Motorcycle R 69 S, R 50 S
Group: Engine

Munich, 3 June 1964
No. 2/64 (209) en.

re: Flywheel Marke for Sport Motorcycles

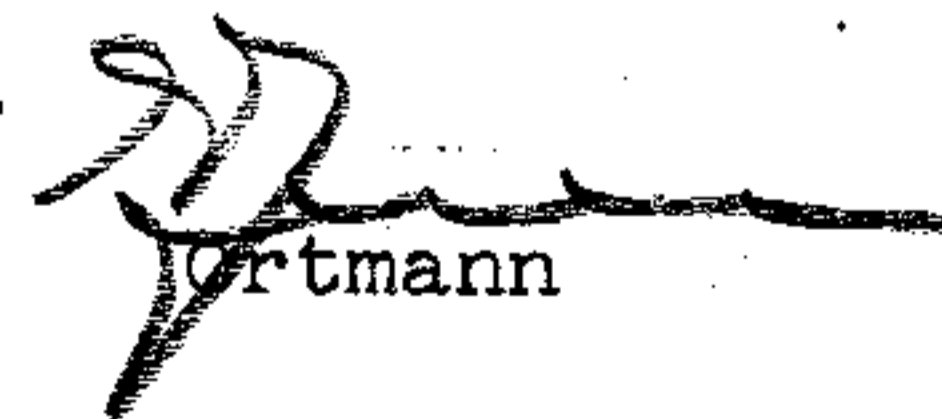
The marks for retarded and advanced ignition of 12° and 42° respectively, before T.D.C. on the flywheel are no longer applicable, since the retarded ignition (initial ignition timing) has been set at 9° before T.D.C..

Commencing with Frame No. 658 164, the flywheel marks on the R 69 S model have been changed to 9° and 39° respectively before T.D.C. Thus the actual flywheel for the S models is now identical with that of the R 50 and R 60 models; the former flywheel-ordering number 00 68.035-is superseded.
